**From:** Eric Taylor <etaylor@oc-n.com>  
**Sent:** Monday, February 28, 2022 9:47 AM  
**To:** Michael Vanderhurst; Jennifer Burrows, Vice Chair; Paul Chang; Jessica Kennedy; Greg Eckert; Lynda Salcido; Sarah Rea; Jamie Gray; Sandra Moberly; John Wentworth; Bill Sauser; Kirk Stapp  
**Subject:** PEDC 3/2 Hearing- Villas III Inconsistencies / Resolution No PEDC 2022-22  
**Attachments:** PEDC Villas III Inconsistencies Letter (2022.02.28) E. Taylor.pdf

**SUBJECT: Inconsistencies of Villas III Subdivision Documents**

### 2.1 Lodestar Master Plan – Maximum Building Heights

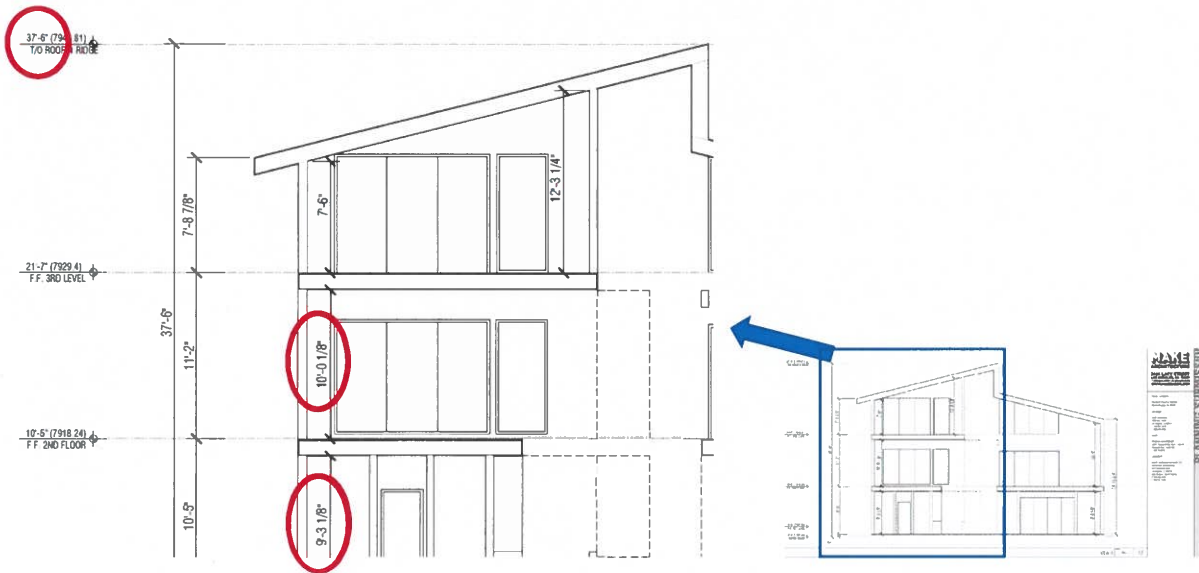
**2. Inconsistent with the Lodestar Master Plan for Maximum Height .**

I strongly object to the proposed height ADJUSTMENT 21-006. The Lodestar Master Plan states clearly that the maximum permissible building height is 35 feet for Development Areas 1, 2, 3, and 4. [ATTACHMENT 2.1]

R2. The Architect's original or new design drawings that do not exceed the 35' height maximum.

### 3.1 SAFER BUILDING DESIGN 3:12 ROOF PITCH

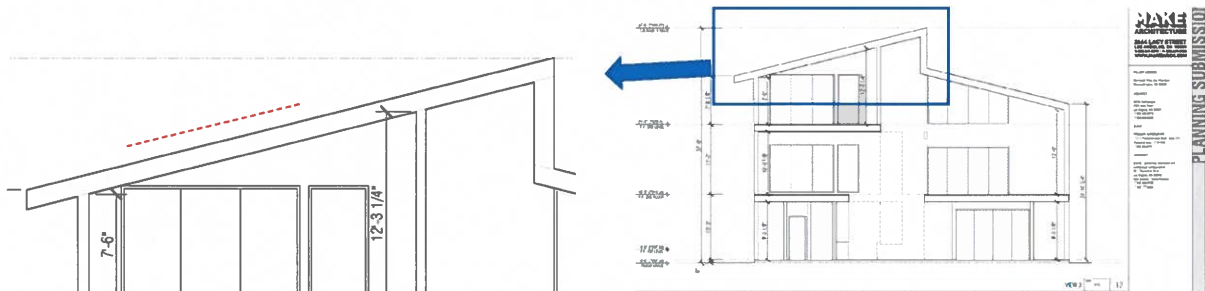
The requested Height Adjustment 21-006 states that the increased height “will result in increased safety of the occupants by allowing for a 3:12 roof pitch.” (Resolution pg. 6 of 178; ATTACHMENT 3.1). I agree that a 3:12 slope in Mammoth Lakes is safer than a 1.5 :12 slope. Why is this 3:12 safety standard not consistently applied to the duplex roofs that show in the Project Plans have just 1.5 :12 slope? [ATTACHMENT 3.2 – 3.3].

### 3.3 DUPLEXES = 1.5:12 ROOF PITCH

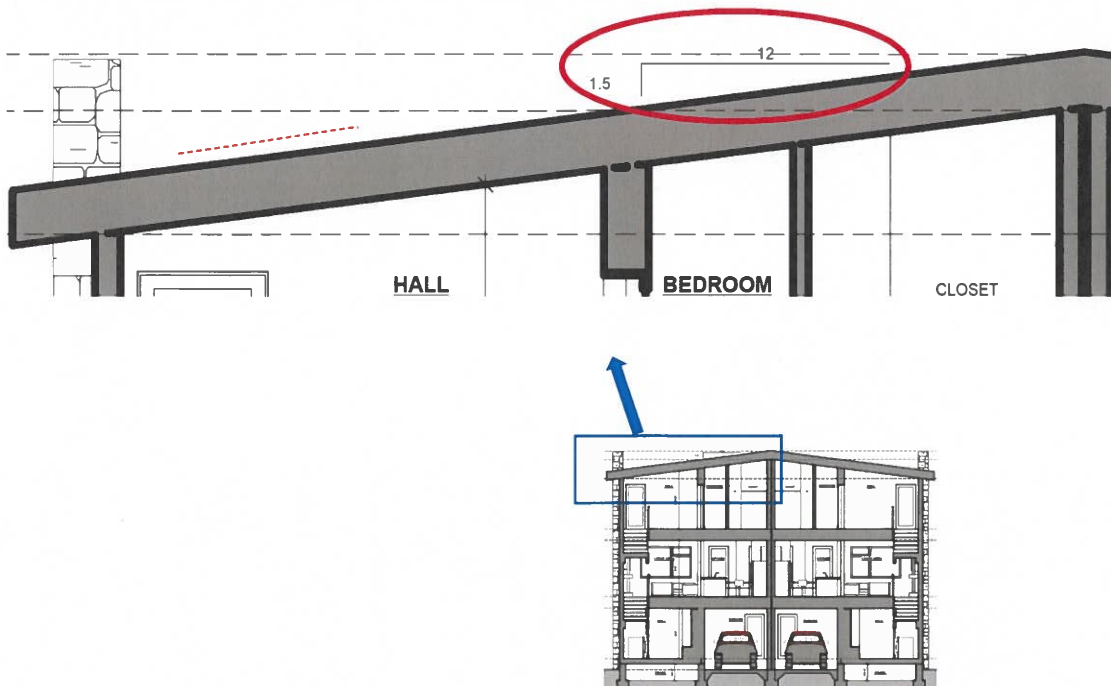
R3. Evidence and an explanation for why a 3:12 is needed for the homes, but only a 1.5 :12 slope is needed for the duplexes.

R4. Evidence that the 1.5 /12 slope on the duplexes is adequate for safety of both the inhabitants and SJV Building E.

R5. Evidence that the 1.5 /12 slope on the duplexes, and units 22-25 specifically, will not cause snow to pile up on the roofs, decreasing estimated sunlight even further.

### 4.1 Existing EASEMENT being Vacated for Villas III

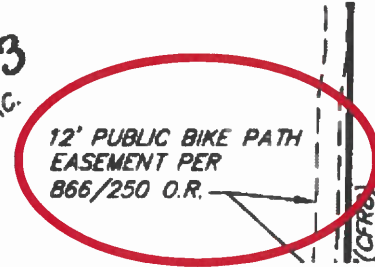
**4. Easement changes shown in the Tentative Tract Map is inconsistent with the State Map Act.** A portion of the Mammoth Lakes Trail System easement is being given away to this development, and there is not clear evidence that all parties have agreed to this. The Tract Map shows that the existing 12-foot easement will be reduced to 11.5-feet [ATTACHMENTS 4.1 – 4.2] and the Villas III development will absorb a portion of the easement for the Mammoth Lakes Trail System (MLTS).

The Tract Map shows that the Villas III development seeks to remove an existing section of the Town Loop Trail and construct a new trail on the eastern edge of the development with a smaller easement. In essence the private Villas III development plans to absorb a portion of the existing MLTS easement, and MLTS has been funded by tax initiative Measure R.

R4. Corrected Tract Map showing 12-foot easement the entire length, or documentation showing that Mammoth Lakes taxpayers and MLTS support giving away this portion of the easement to this development.

### 4.2 Villas III Proposed Reduction to Existing 12' Easement to 11.5'

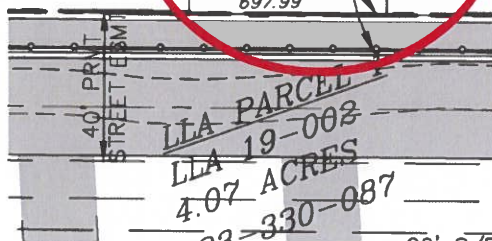
The reduction of the Easement is a violation of the State Map Act [ATTACHMENT 4.3] unless it has been approved by MLTS and the funders of MLTS. The MLTS program <https://www.mammothtrails.org/about/> is funded by the local special tax initiative Measure R. As part of the MLTS *The Town Loop trail* is described as, “The main hub of the Mammoth Lakes Trail System. [ATTACHMENT 4.4]
